THE CITY OF SAN DIEGO

# ADDENDUM TO A ENVIRONMENTAL IMPACT REPORT

Project No. 516820  
Addendum to EIR No. 233958  
SCH No.: 2011031074

SUBJECT: **BALBOA PARK PLAZA DE PANAMA PROJECT:** The following approvals are being requested in association with the project: AUTHORIZE A COOPERATION AGREEMENT BETWEEN THE CITY AND THE PLAZA DE PANAMA COMMITTEE, AUTHORIZE THE MAYOR TO AWARD A CONSTRUCTION CONTRACT FOR THE PROJECT, and AUTHORIZE FUNDING for Project. The Plaza de Panama Project, as previously approved proposes to remove vehicular access and parking from the Plaza de Panama, El Prado, Plaza de California, the Mall, and Pan American Road East and allow these areas to be used by pedestrians only. A new bridge, "Centennial Bridge," would connect the eastern end of Cabrillo Bridge to the western side of the Alcazar parking lot. From that point a new "Centennial Road" would traverse through the Alcazar parking lot exiting to the east, continue to the south past a new Organ Pavilion parking structure and then connect to Presidents Way. Additional parkland would be provided atop the new parking structure. A tram would provide service from the parking structure to the Plaza de Panama with

FIGURE 6  
Other BMPs

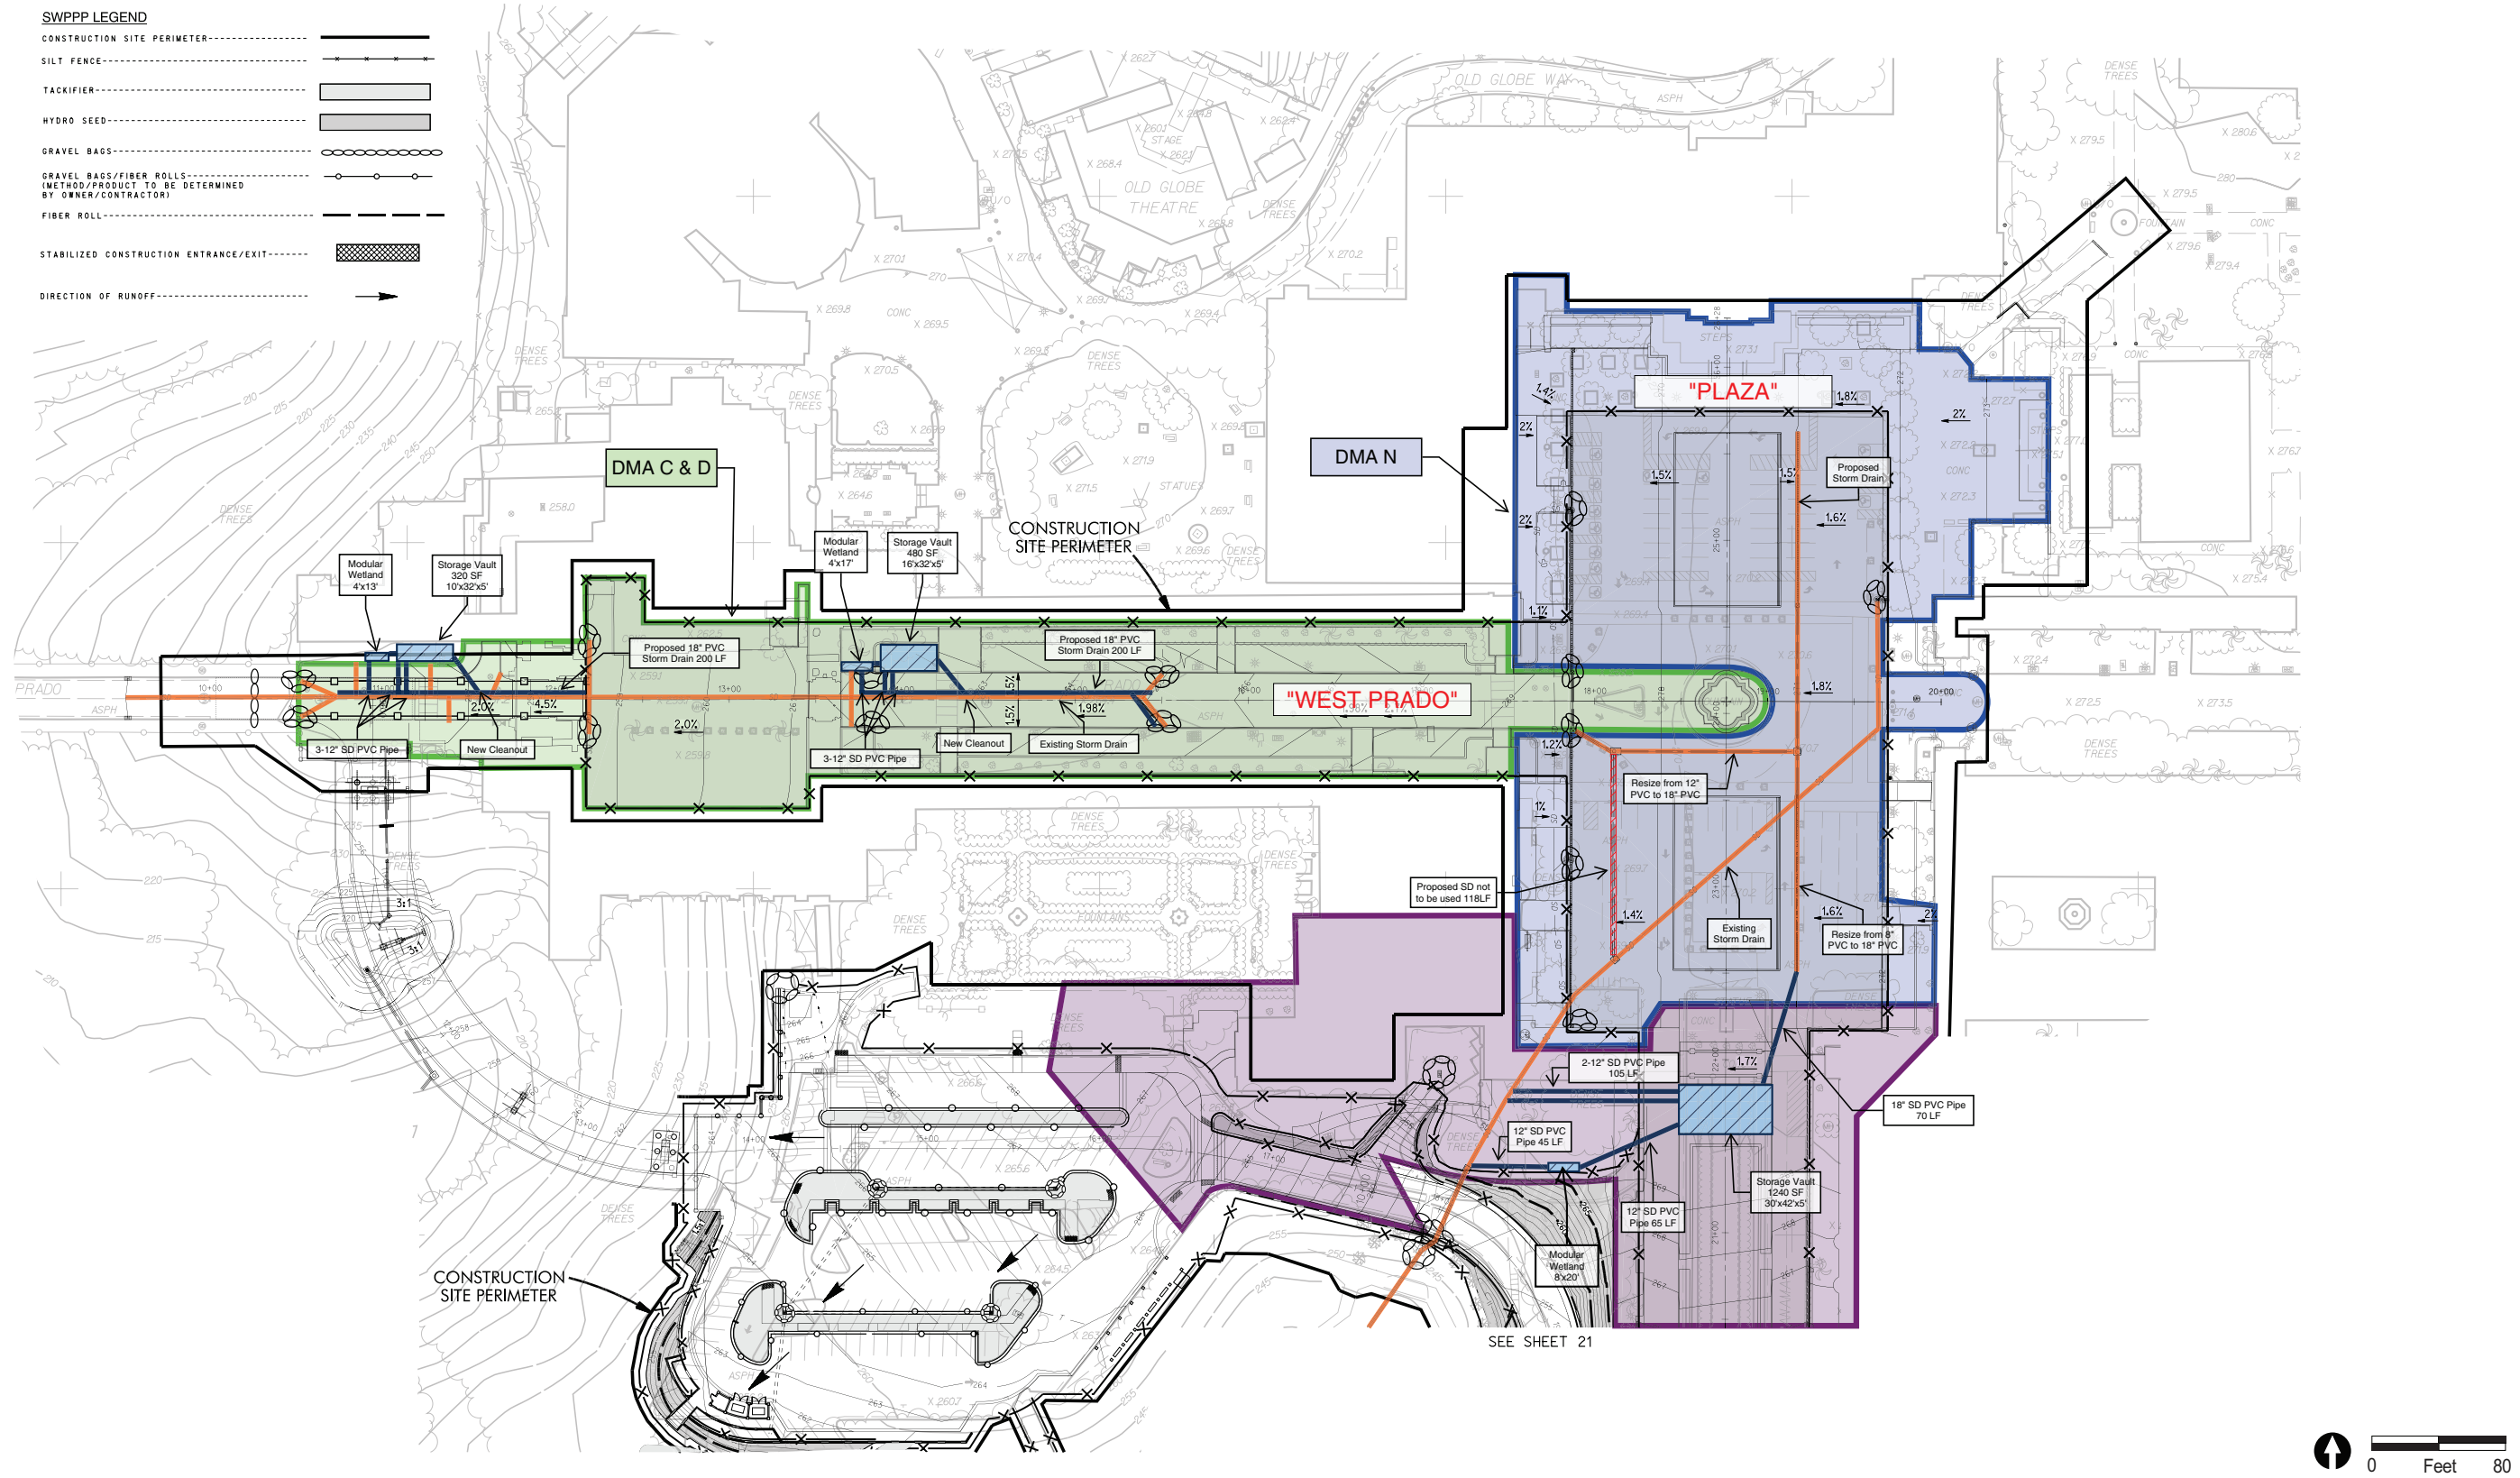
- **Other** – Additional storm water control would also be required at the West Prado, the Esplanade area, and northwest of the Plaza de California (Figure 6). Compliance would take the form of three proprietary biofiltration BMPs (e.g. modular wetlands). The modular wetlands are engineered devices which are installed underground such that only the surface is exposed. The surface is vegetated and would result in negligible visual impacts. Each of the wetlands is paired with a storage vault which stores and releases the storm water slowly. The storage vaults are completely underground and would not be visible.
